QTY REQD		ITEM NO	REF DES	CAGE NO	PART OR IDENTIFYING NO	NOMENCLATURE OR DESCRIPTION	SPECIFICATION	MATERIAL OR NOTE	ZONE
					20007918-1				
					PARTS LIST				
CONTRACT NO		UNLESS OTHERWISE SPECIFIED DIMENSIONS ARE IN INCHES			<p><b>RELEASED</b> 2/17/2005</p> <p>ALLIANCE SPACESYSTEMS, INC. 1250 Lincoln Ave., Suite 100 Pasadena, CA 91103</p>				
NEXT ASSEMBLY		MACHINE FINISH 125			<p>ADAPTOR, STAGE 1-2 VERTICAL COIL LIGO D047918-B</p>				
APPLICATION		MATERIAL			<p>AL 7075-7651 AMS-QQ-A-250/12</p>				
20007969		1388			<p>SIZE E CAGE CODE 1KNU9 SCALE 2:1</p>				
		20007918.x_1			<p>REV B UNCLASSIFIED SHEET 1 OF 1</p>

VIEW A-A  
TYPICAL 2 PLACES

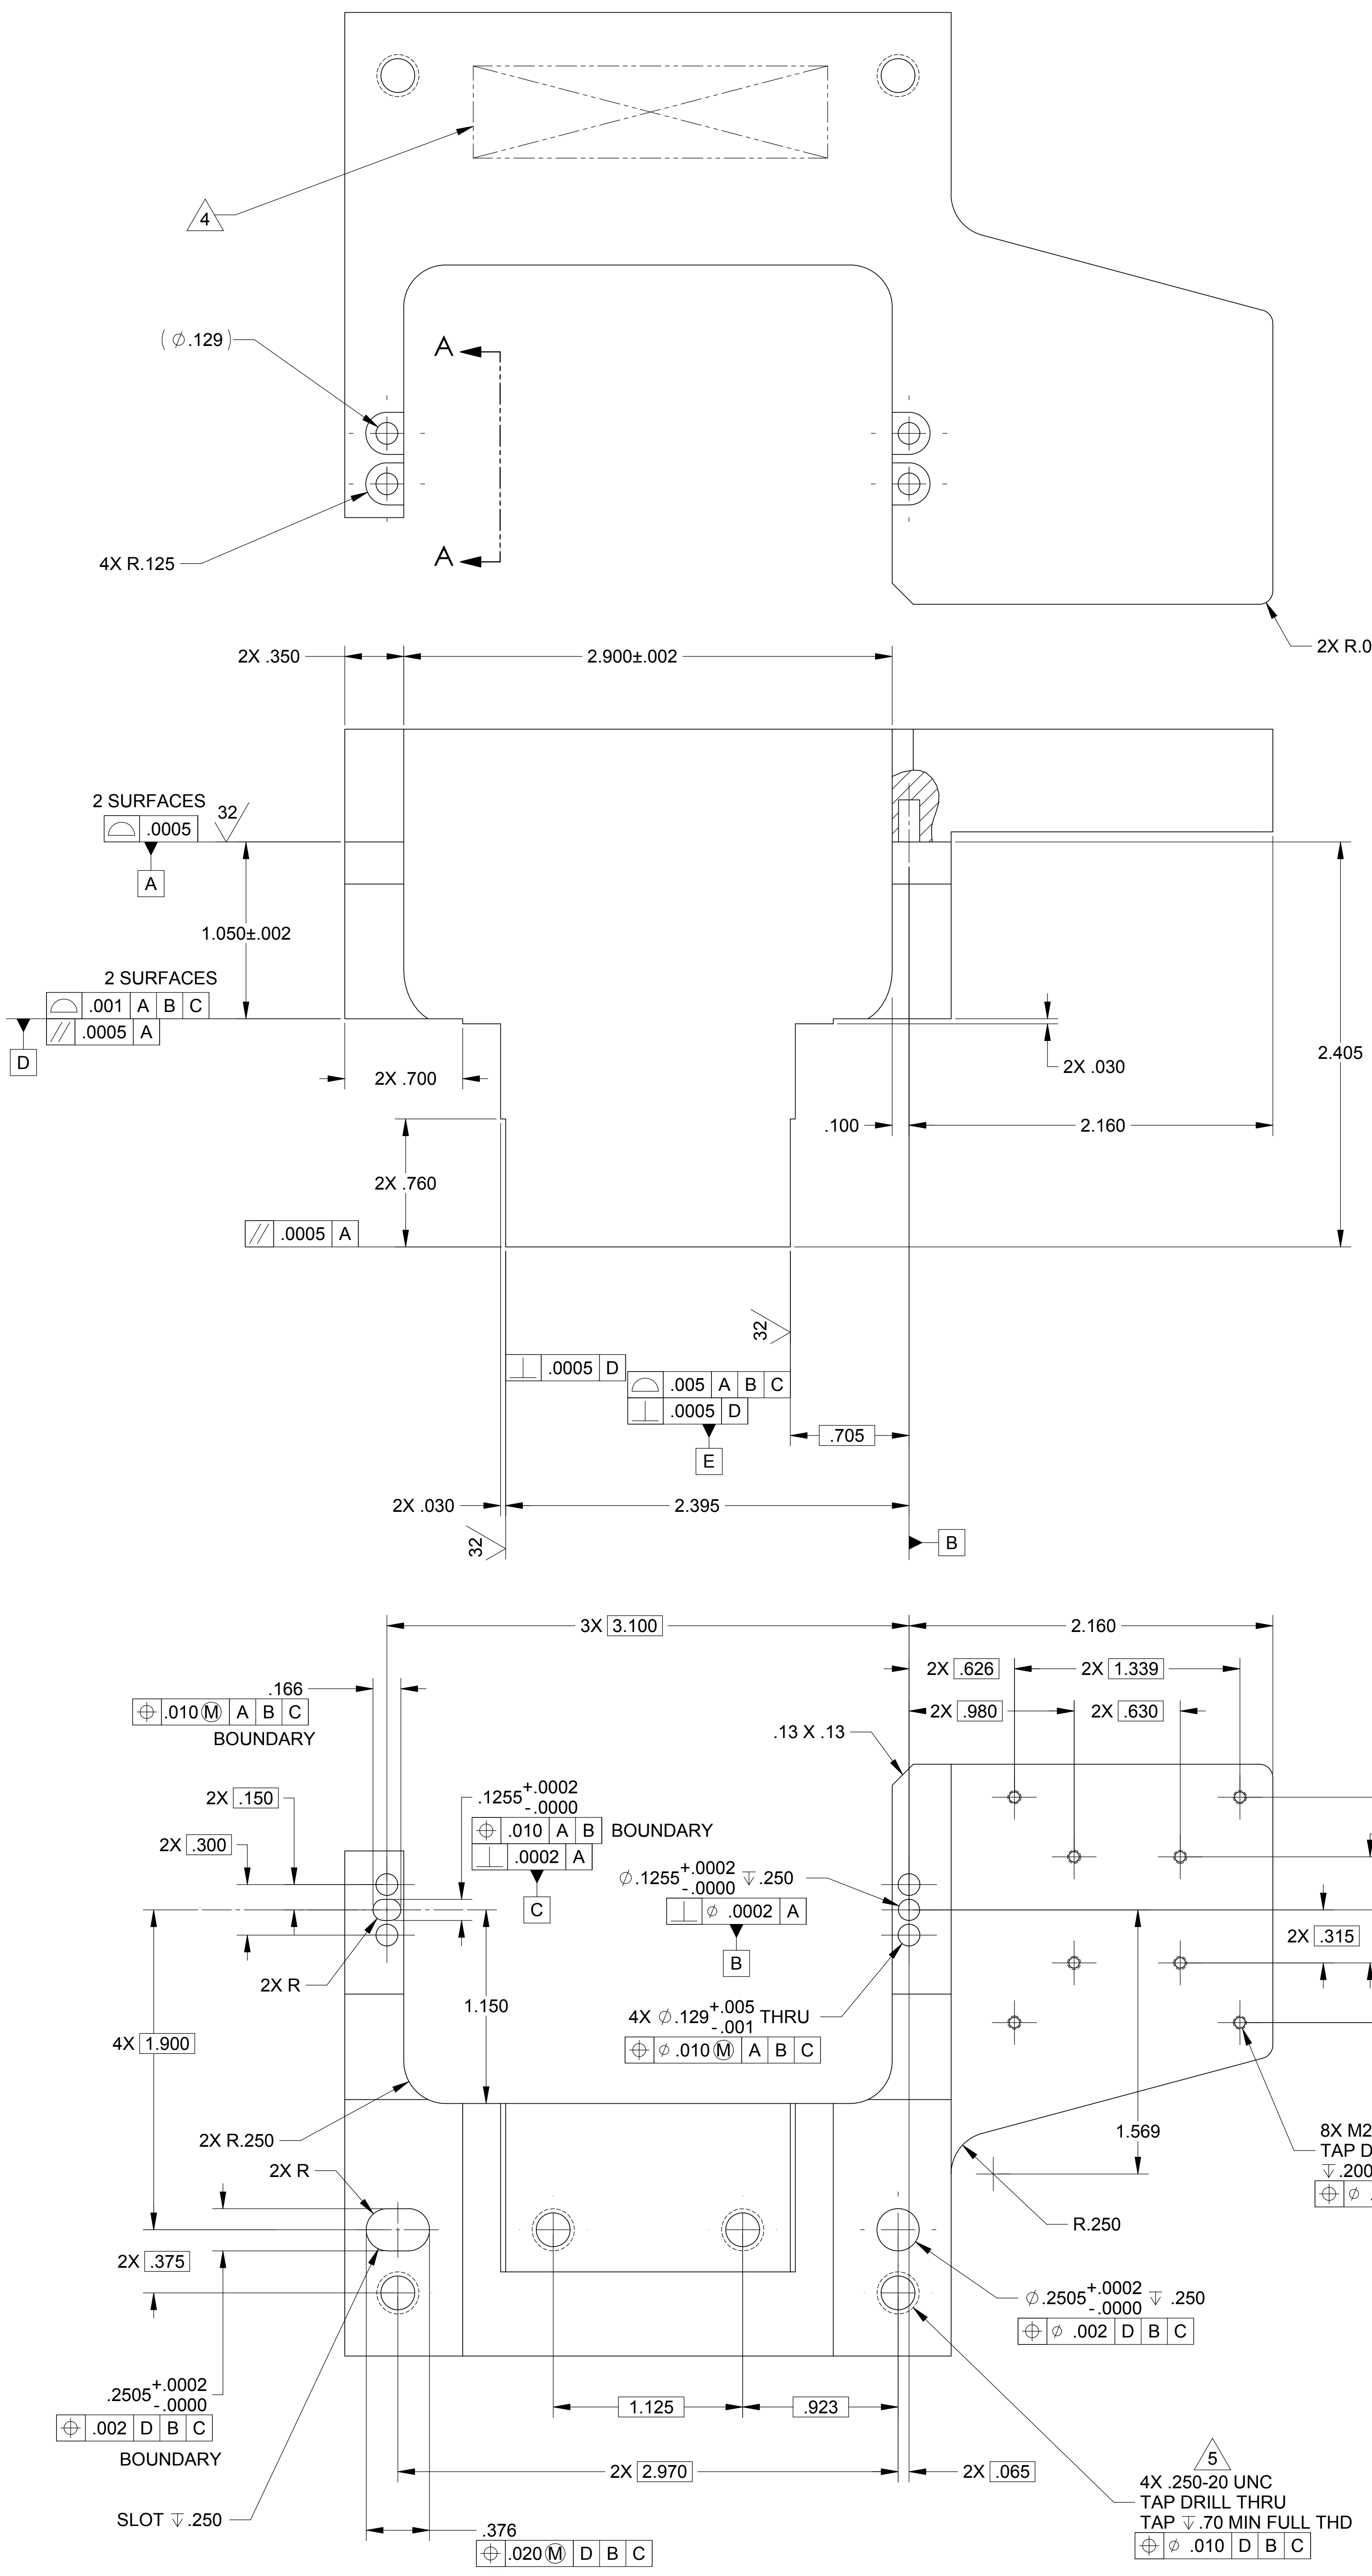
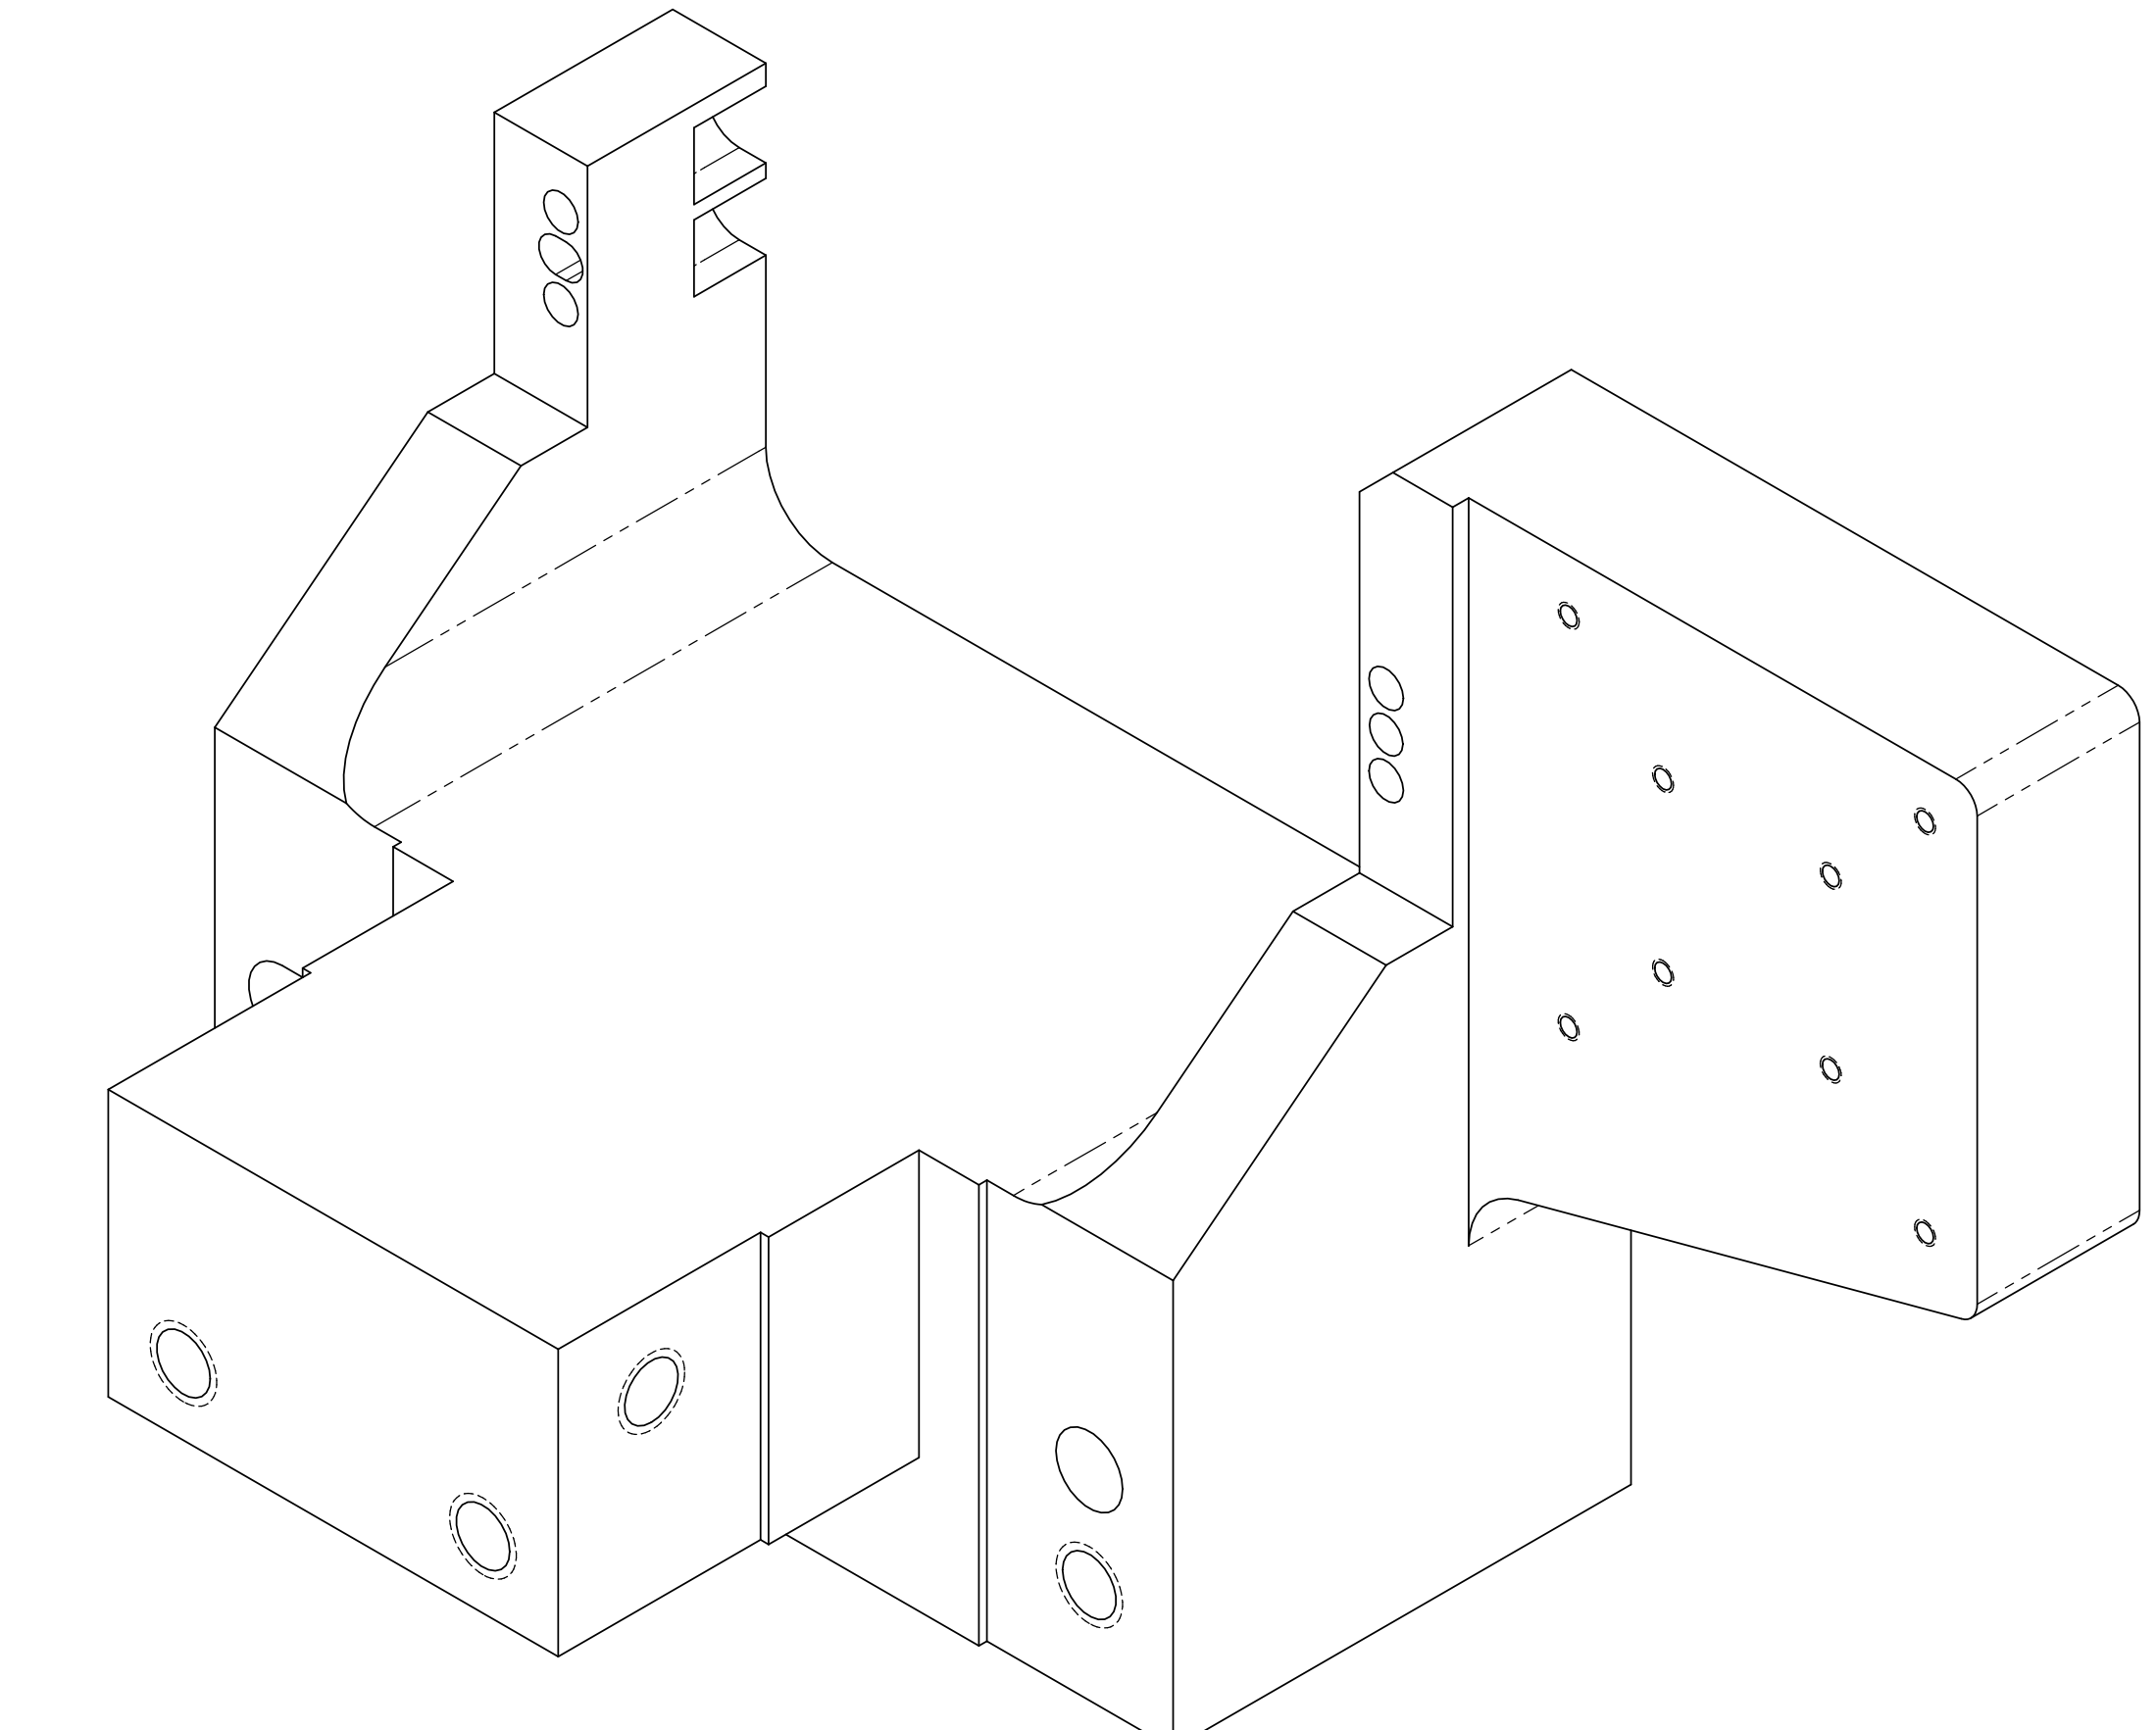
LTR		ZONE		REVISIONS									
NO.	DATE	BY	CHK	P-ENG	CONF	ME	STRS	MATL	PROJ	QA	RELEASE DATE		
A											INITIAL RELEASE		
A											INITIAL RELEASE		
B	AG										.250-20 UNC HOLE TAP CALLOUT WAS: $\nabla$ 900 MIN. IS: THRU
